THE CITY OF KEY WEST
Post Office Box 1409
Key West, FL 33041-1409

ADDENDUM NO. 1
ITB 15-013
PROJECT CE1002 - CEMETERY SEXTON'S HOUSE

SEAL OF THE CITY OF KEY WEST, FLORIDA	City of Key West Engineering Services 3132 Flagler Avenue Key West, FL 33040	TITLE ITB 15-013 Bid Alternate #10 - ADA Ramp	
		DRAWN GJV SCALE 1" = 5'	Sexton's House - 701 Passover Lane 2/12/15 SHEET 1 of 1

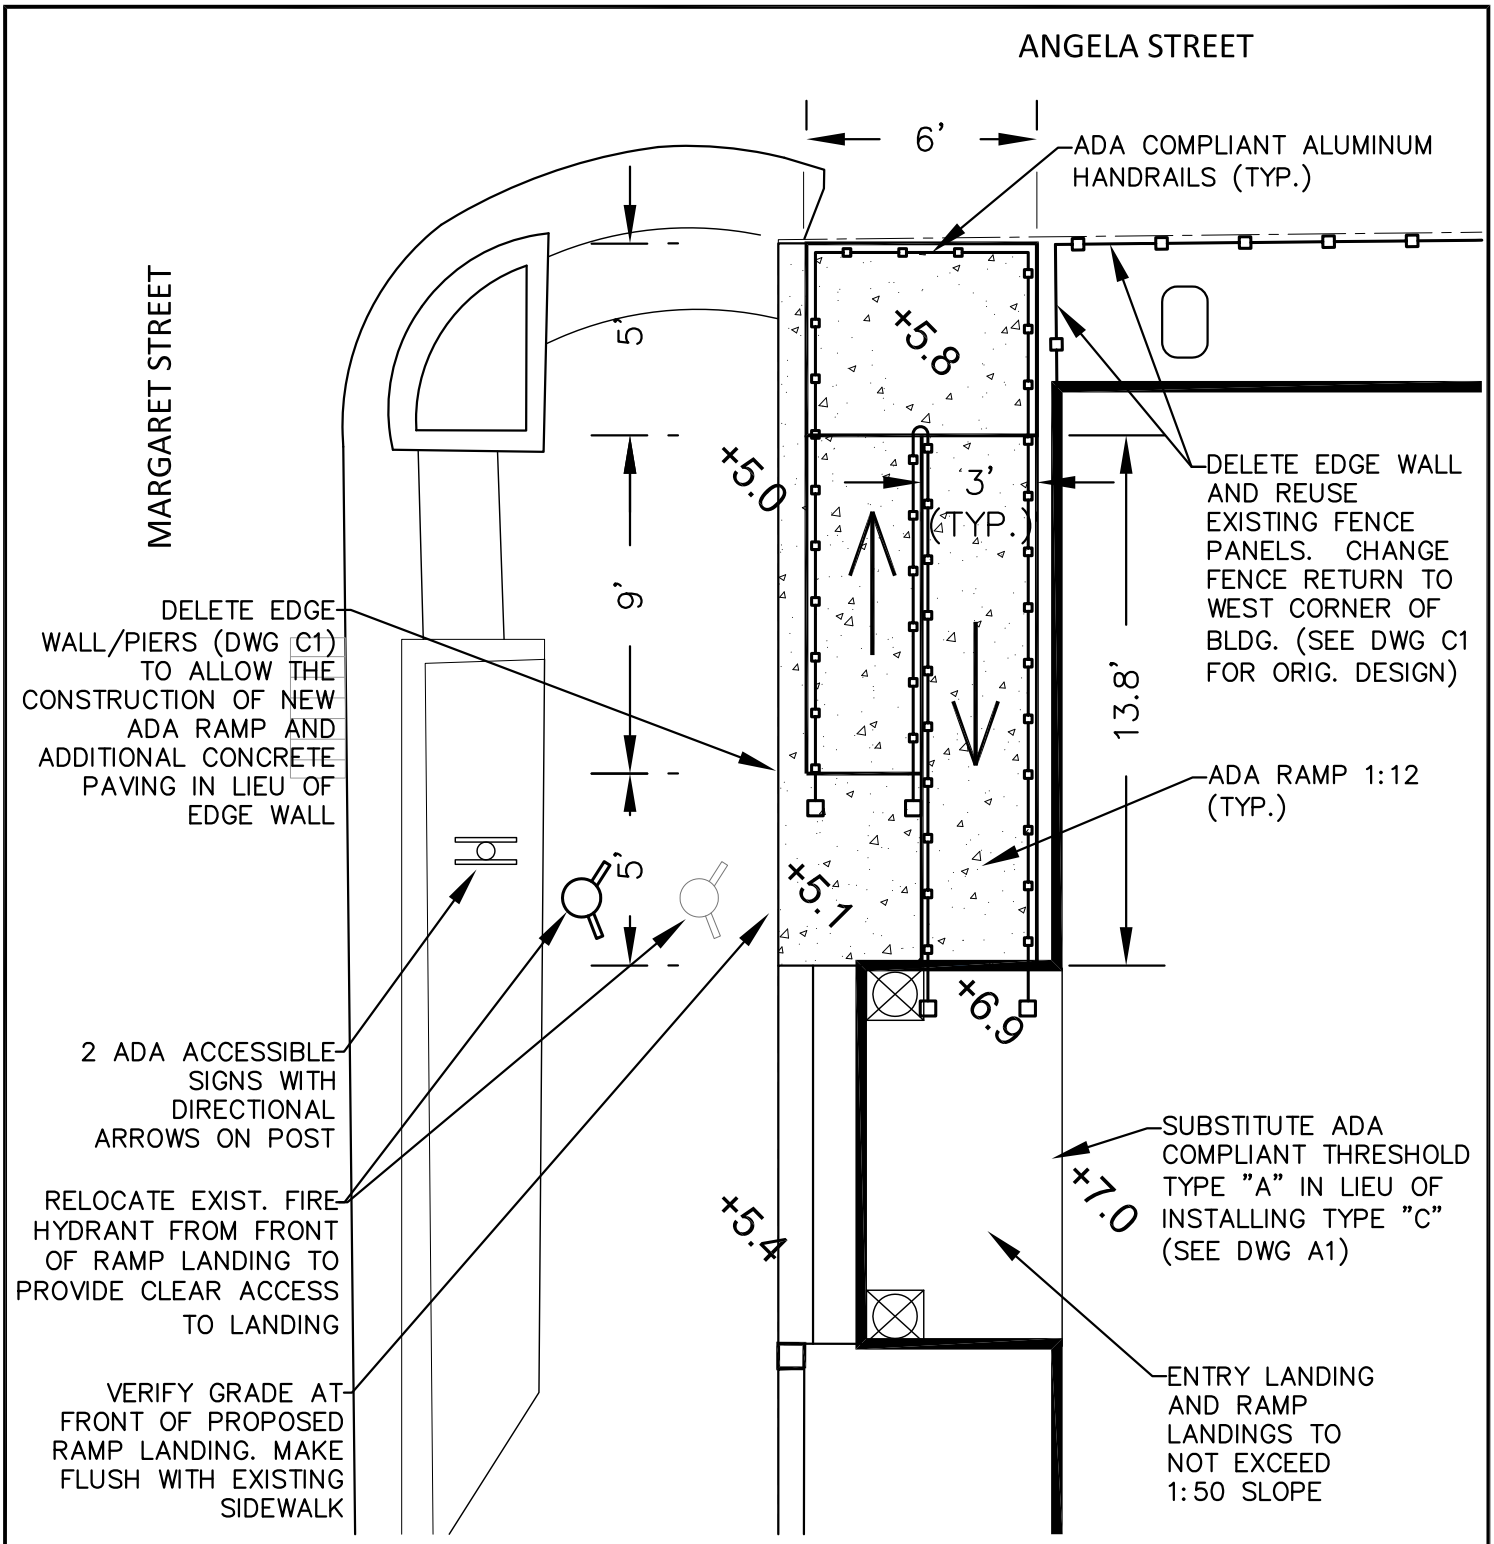
4. **ADA Ramp - Bid Alternate No. 10 - Sheet 1** enclosed. Furnish and install ADA Access Ramp with ancillary items to front door porch in lieu of constructing all Edge Walls with Piers and Swale A.
